**WHITE LAKE TOWNSHIP
INTER-OFFICE MEMORANDUM
COMMUNITY DEVELOPMENT DEPARTMENT**

**SUBJECT: Ginko Self Storage
Amended Final Site Plan**
located on the north side of White Lake Road, west of Old White Lake Road, consisting of 2.14 acres. Currently zoned Light Manufacturing (LM). Identified as vacant parcel 12-01-127-004
Applicant: Ginko Investments, LLC

RE: **Ginko Self Storage -Final Site Plan/Final Engineering Plan Review-4th Review**
~~Stormwater Maintenance Agreement Review-1st Review~~

Revised Final Site Plan Review for Special Land Use for White Lake Charter Township, Michigan

Attachments: Sheet C-7.0- Red Lined

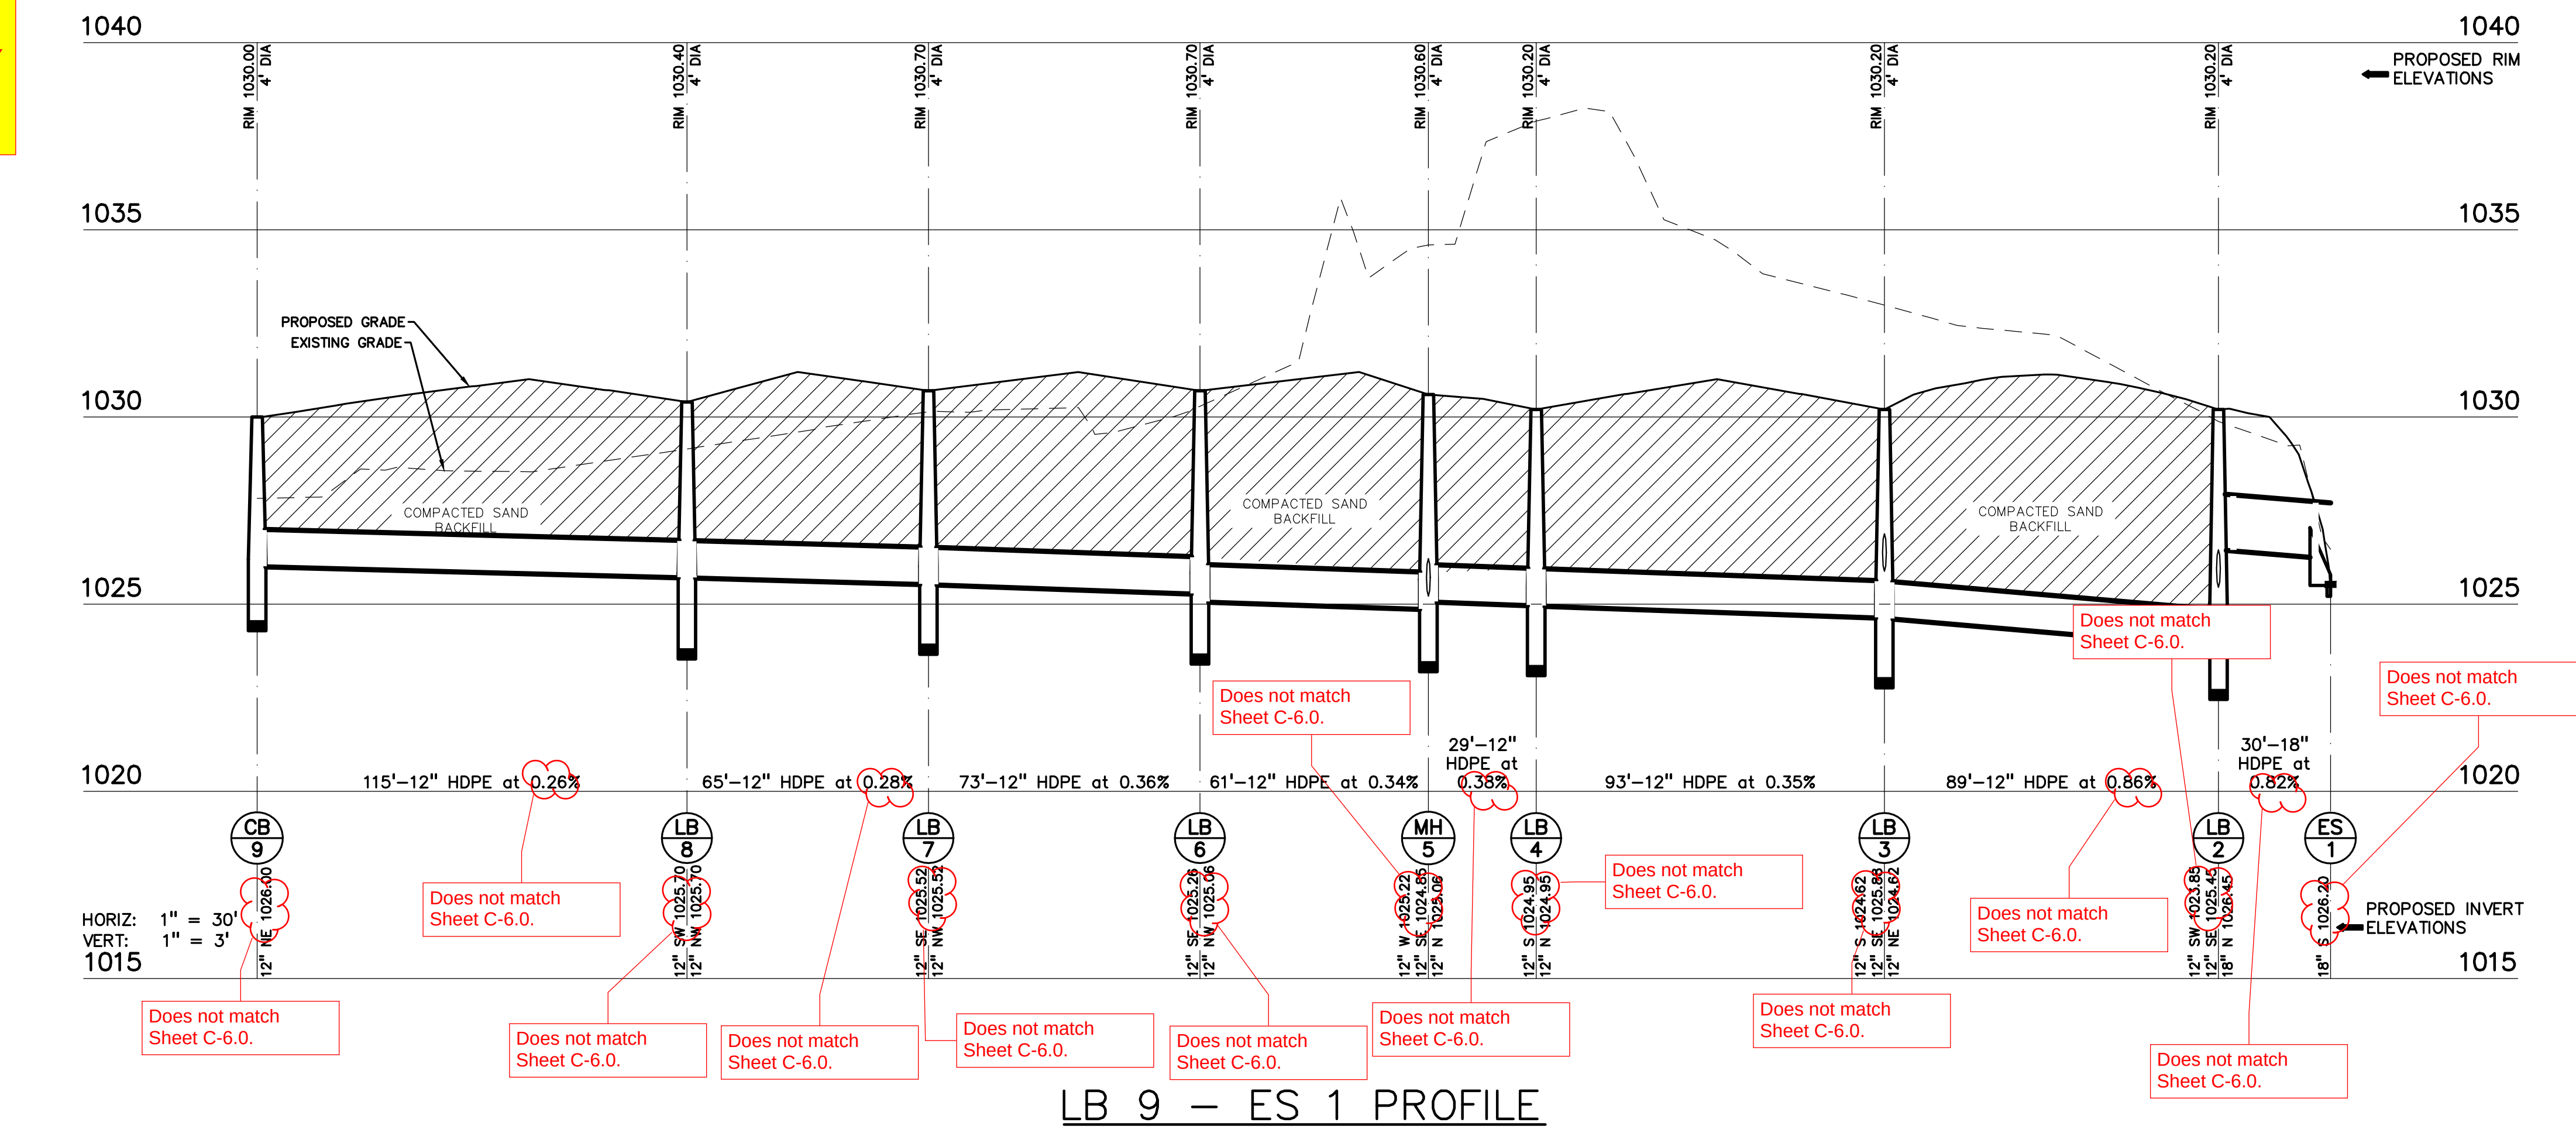
3. Sheet C-7.0- It appears that profiles were not updated based on revised storm sewer structure rim and invert elevations. We have attached a red lined copy of this sheet.

SITE PLAN

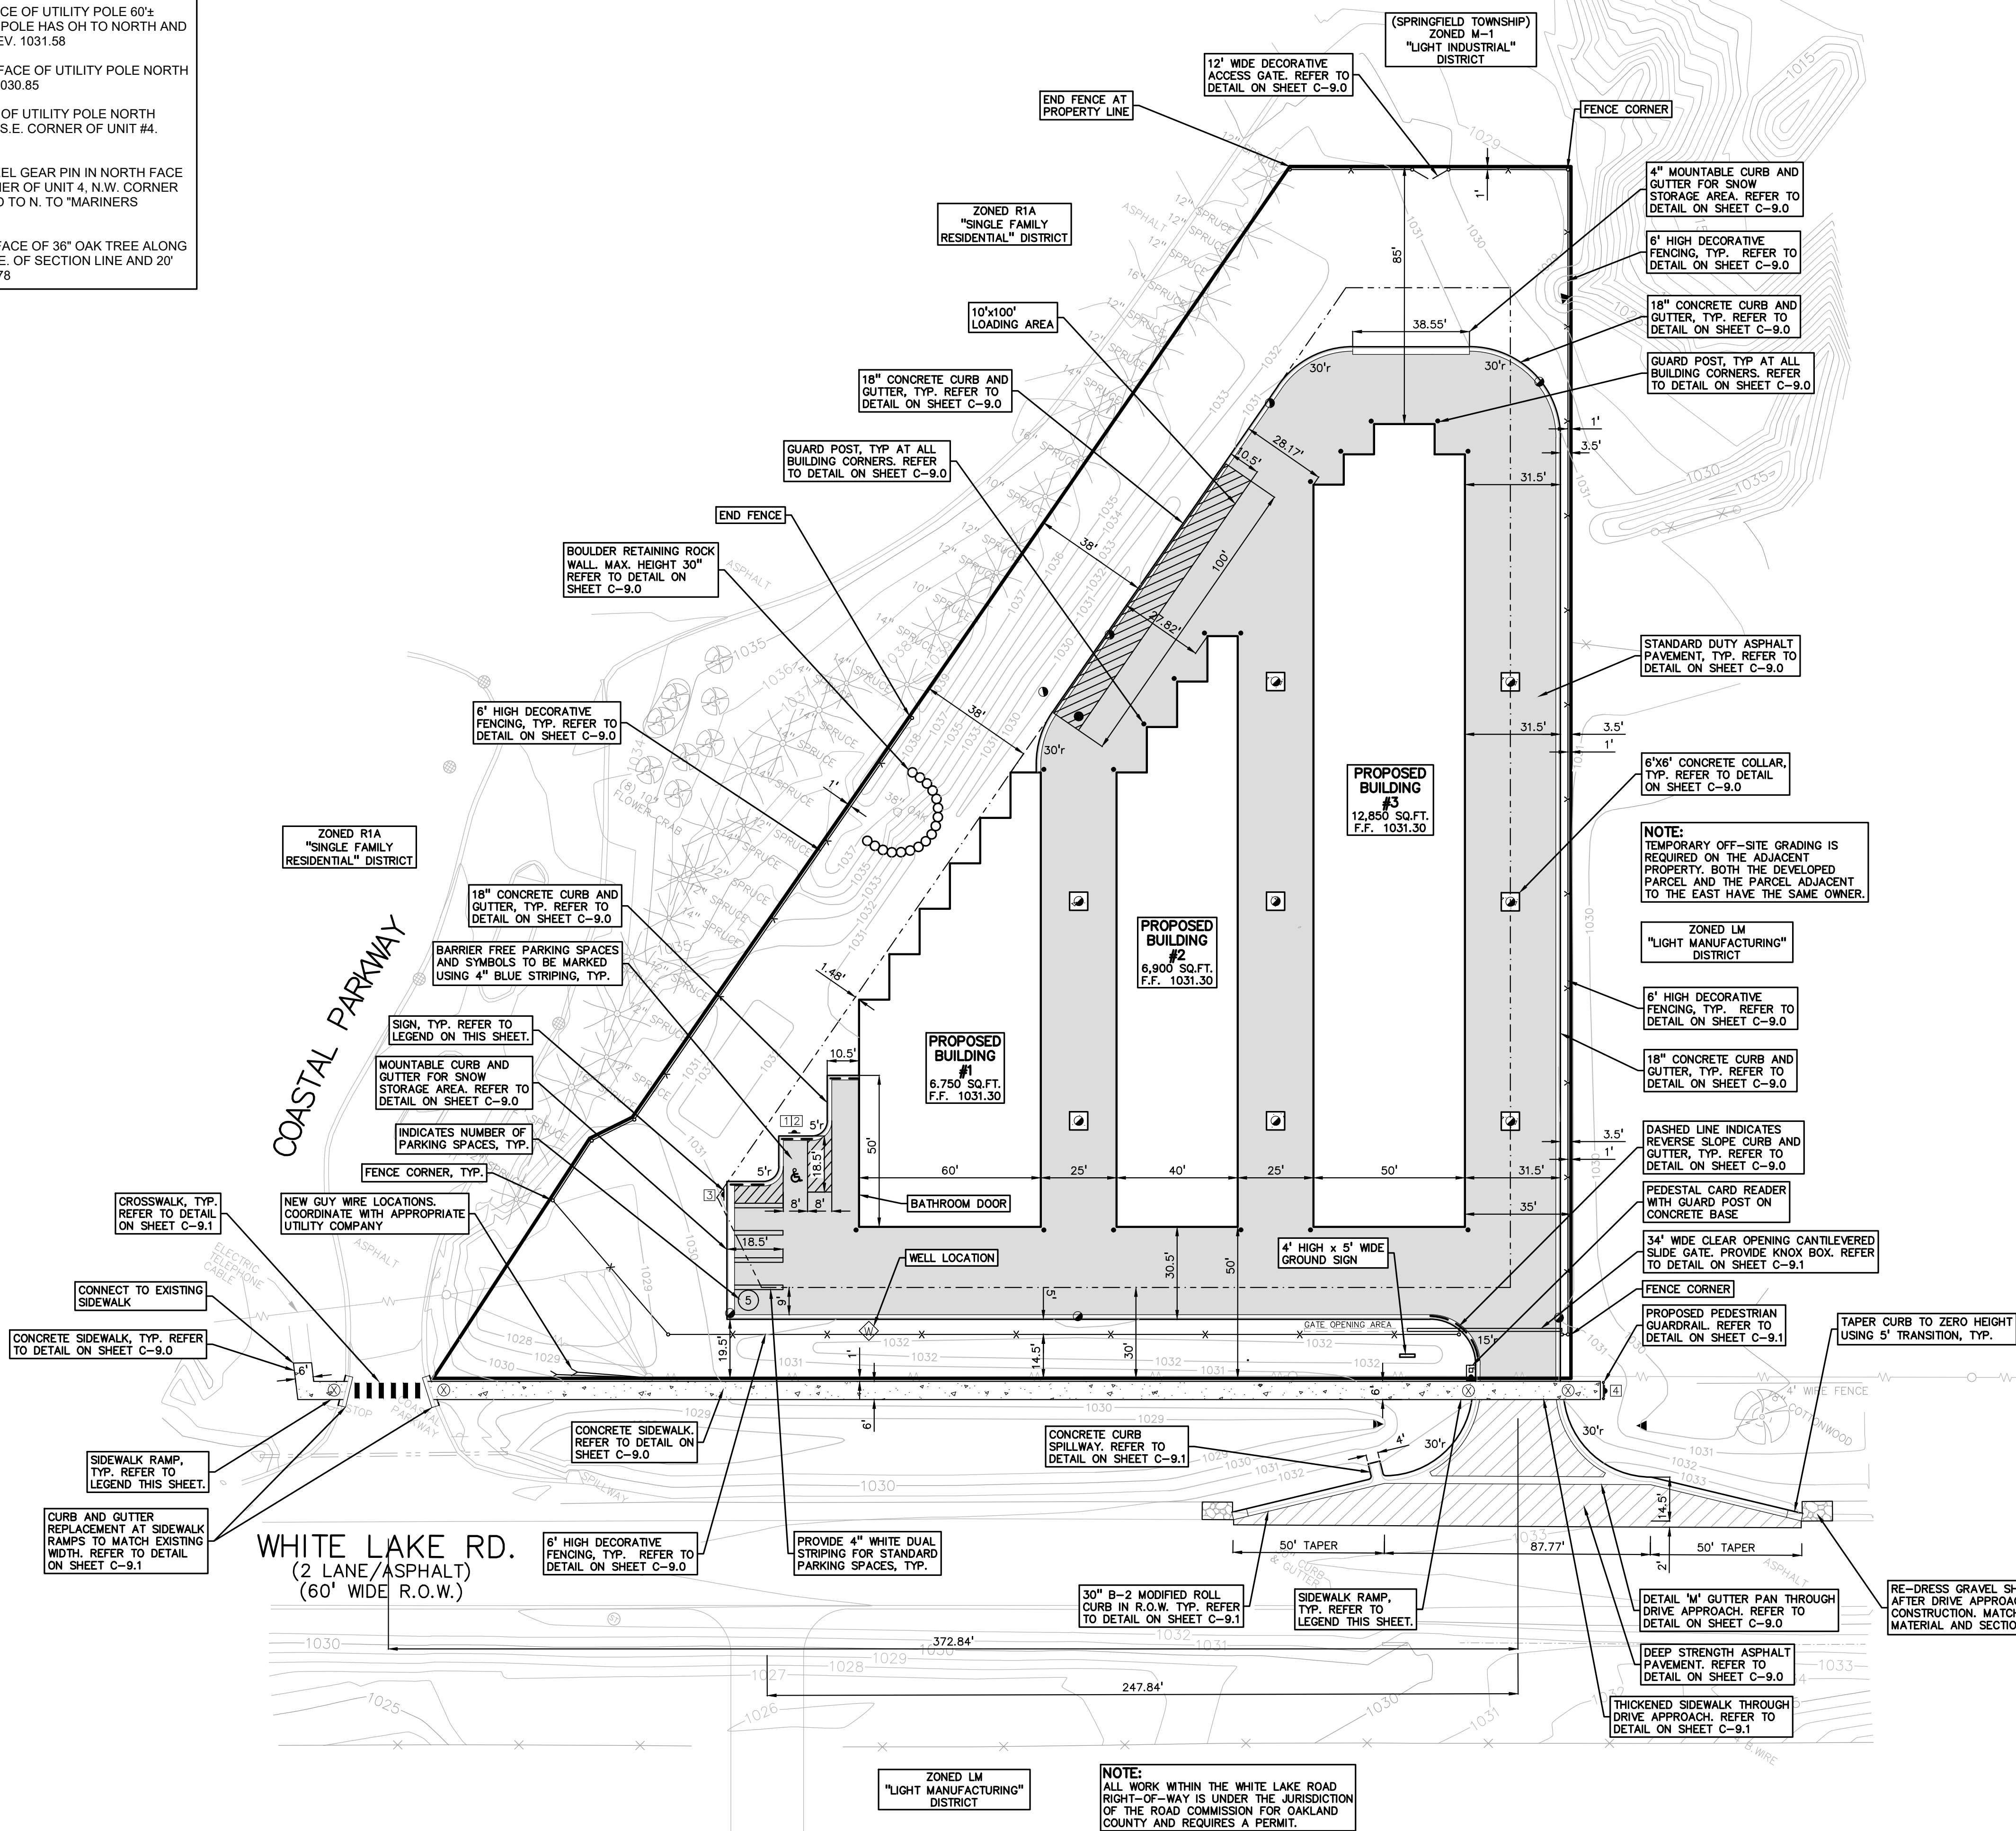
1. Sheet C-3.0- Striped crosswalk at drive entrance has now been eliminated. Is this the intent or is this in error?
2. Sheet C-4.0- Provide ADA parking blowup for this area; this was shown on the previous submittal.

We also note an access drive located on the opposite side of the road. The distance shown between these is 274 feet. This does not meet the requirement of a minimum of 350 foot distance and will require a waiver from the Planning Commission per Section 6.4.F. Final design of the access drive will require Oakland County Road Commission (RCOC) approval.

Section 5.11 outlines requirements for off-street parking. Sheet C-3.0 provides parking calculations for a self-storage establishments. There is no office space provided within the buildings, nor is any information provided about employees. Five parking spaces, including one handicap space is provided and appear sufficient for operational needs given most vehicles will temporarily park alongside their respective storage units for loading/unloading purposes.

Items to be Addressed: Parking space layout will need to be modified to maintain the 20-foot landscaped buffer setback or a variance will be required from the Zoning Board of Appeals.

**FIRE TRUCK
TURNING
MOVEMENTS**

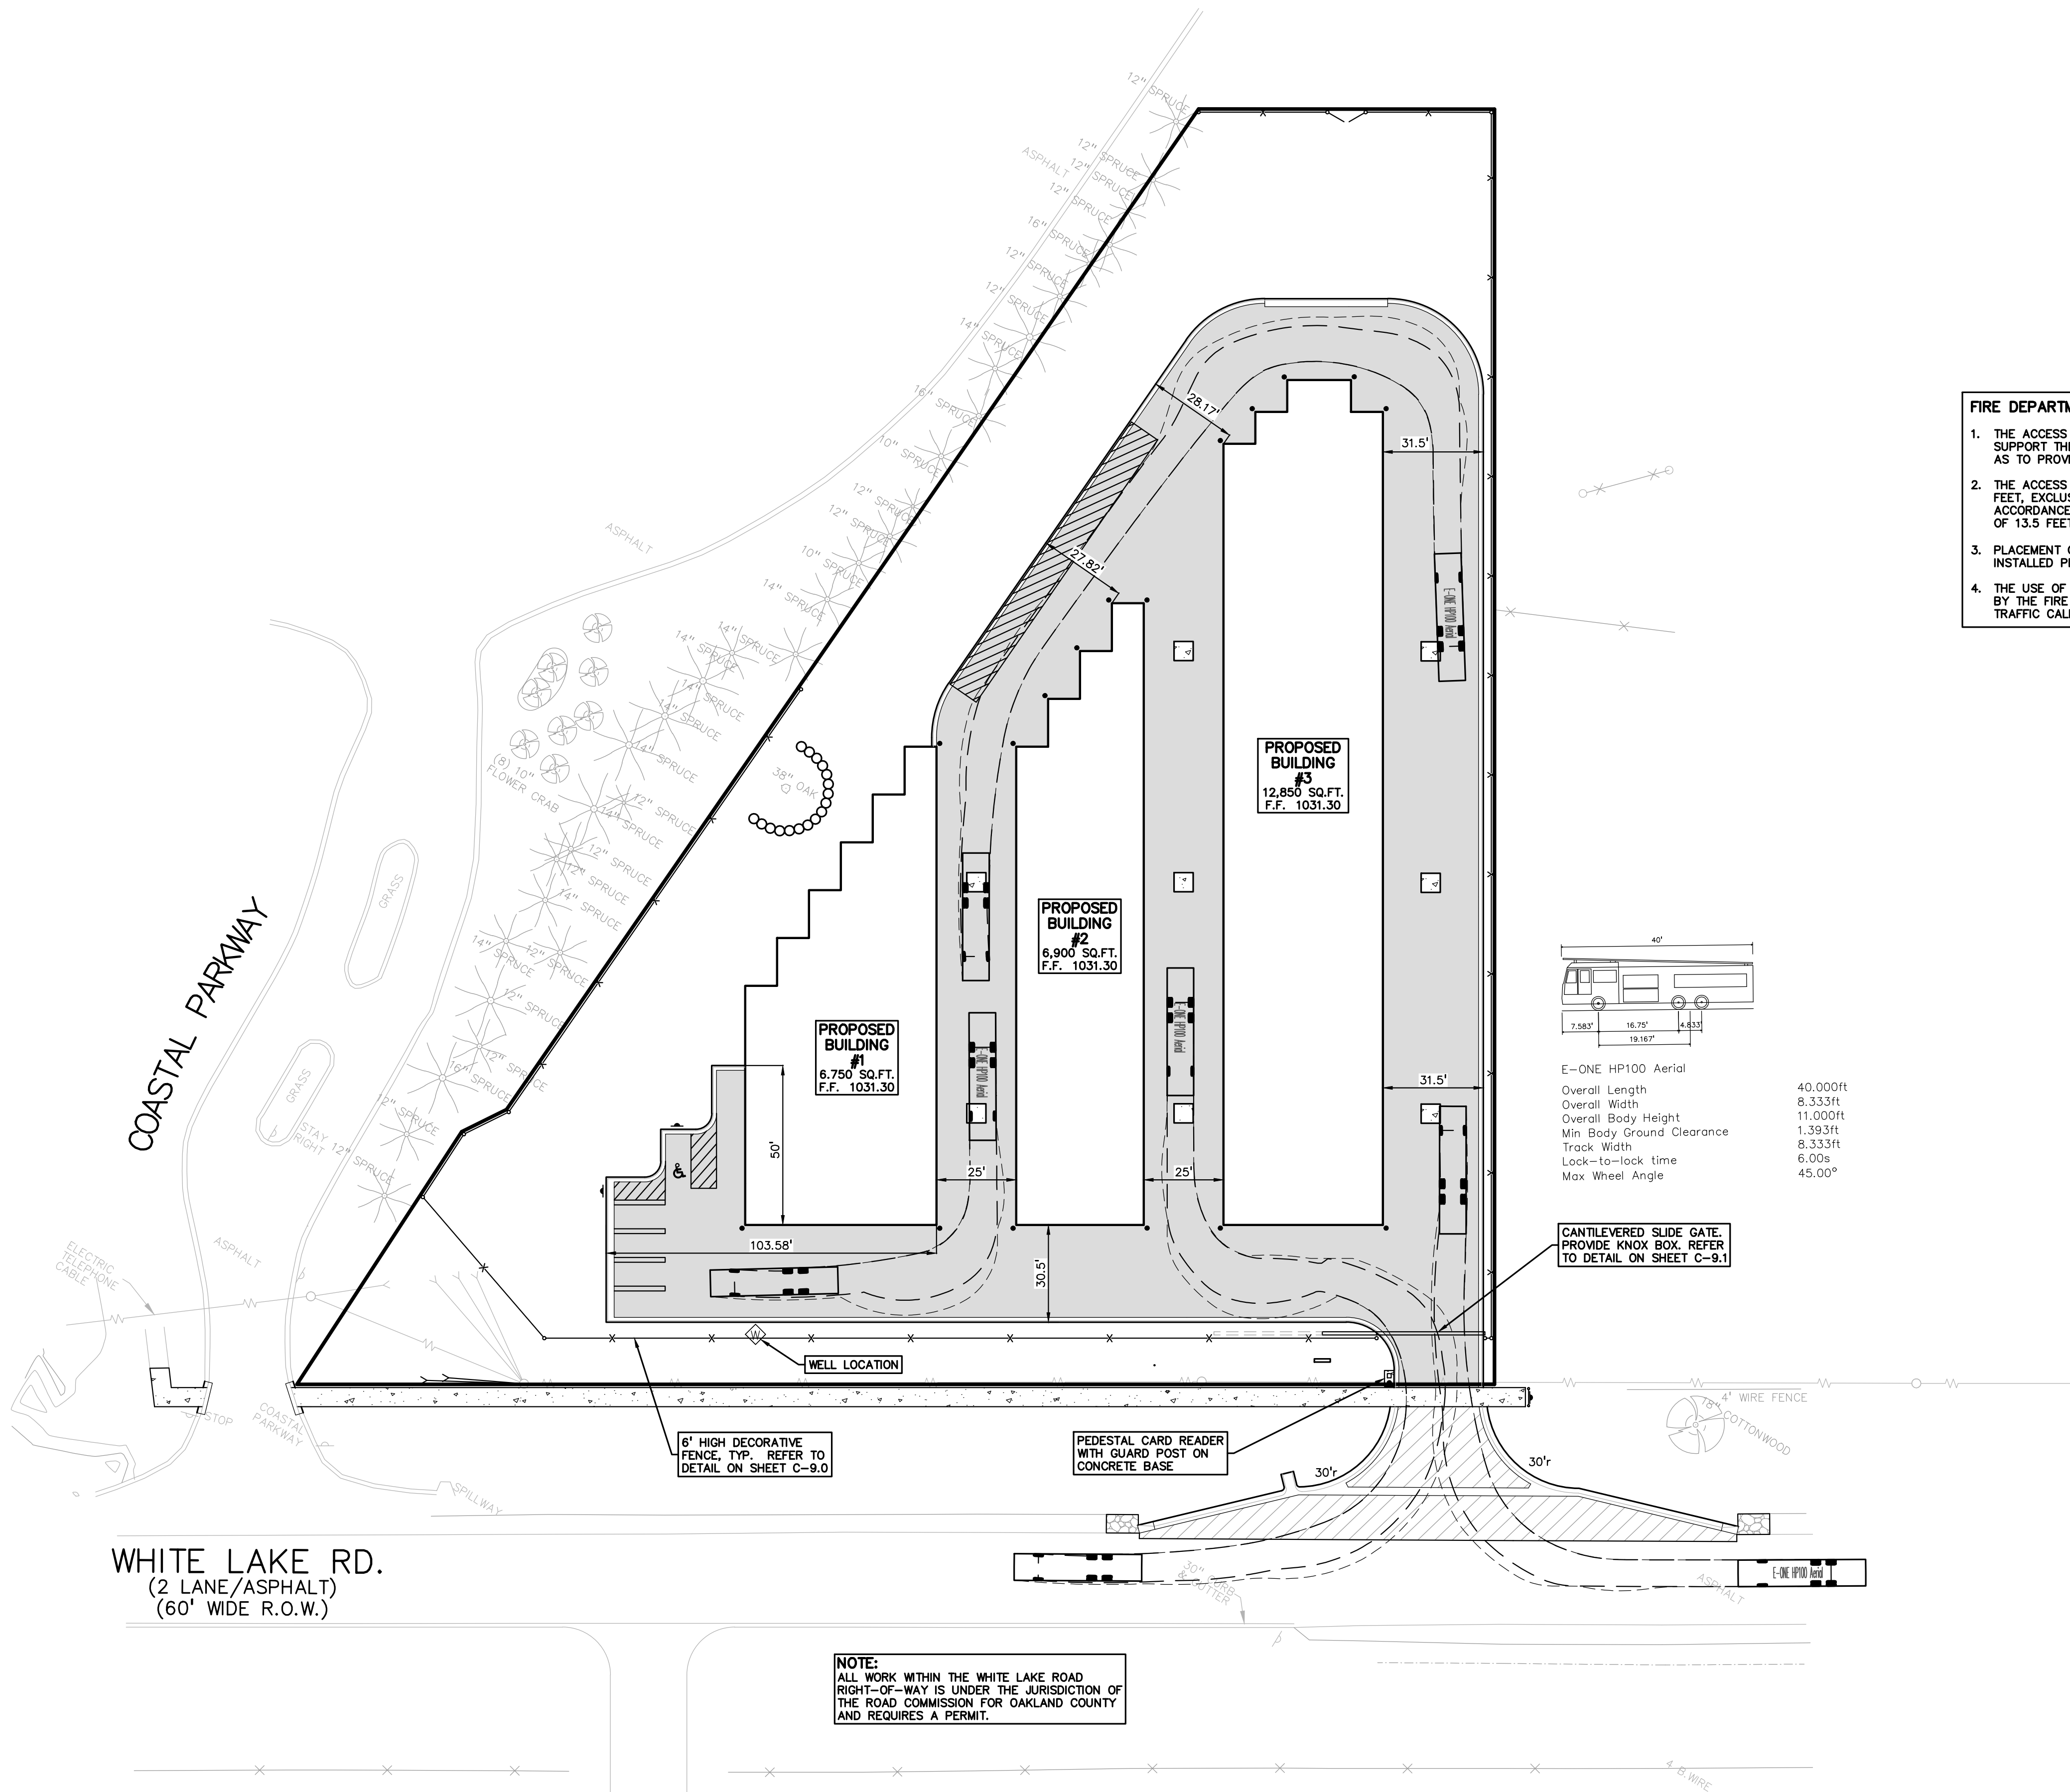
Sheet C-3.1 outlines maneuvering capabilities for fire trucks. We defer to Township Engineering to assess the conformance of lot design and Public Safety to assess the conformance of maneuverability and accessibility for the site.
